Re: **Proposed Mixed-Use Project (Garage Addition): Revised Site Plan and Architectural Review Submittal**  
**5877 Main Street**  
**Williamsville, NY 14221**

In response to the Town of Amherst Planning Department comment letter dated February 27, 2024, we offer the following responses:

## 8 Bay Garage - Floor Plan And Concept Rendering

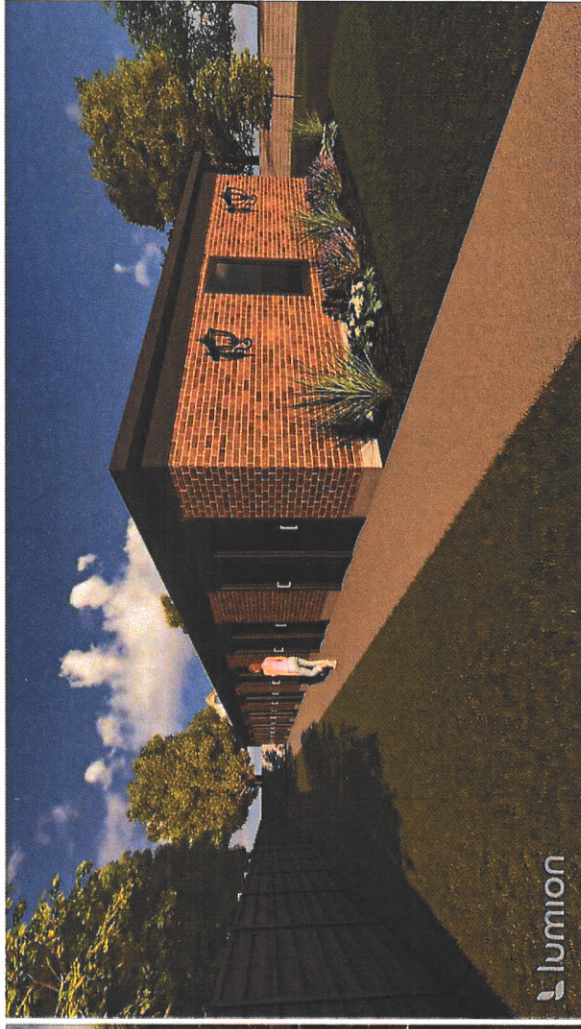
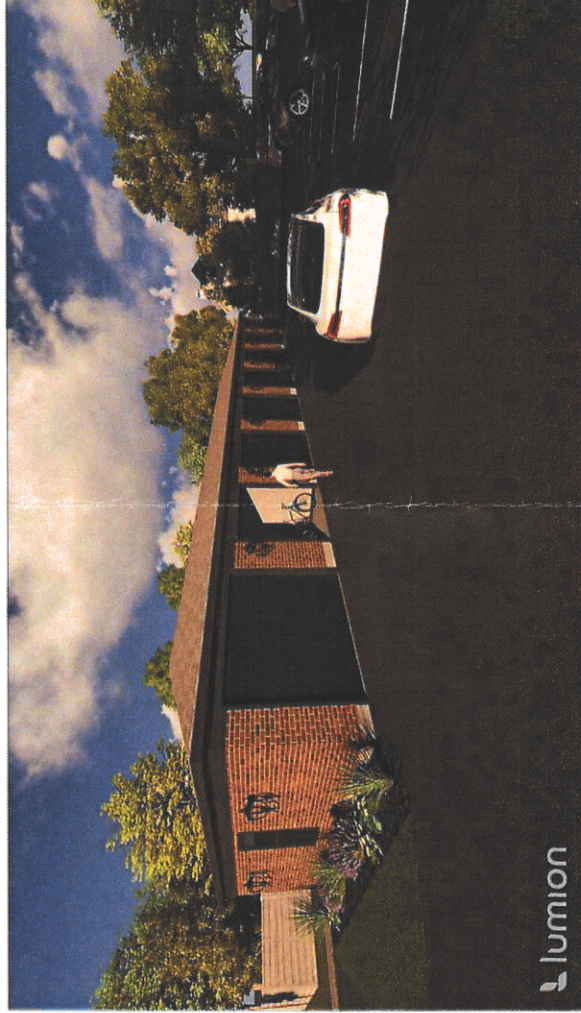
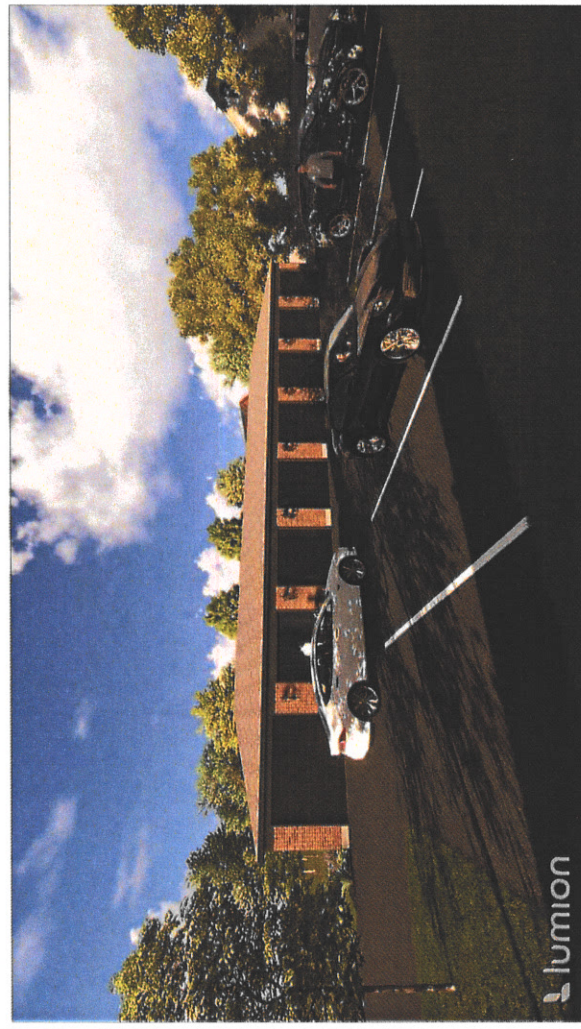
*Comment #2: Provide full sized (24" x 36"), dimensioned, color elevation drawings for review.*

**Response: Full size elevation drawings are included in this submittal.**
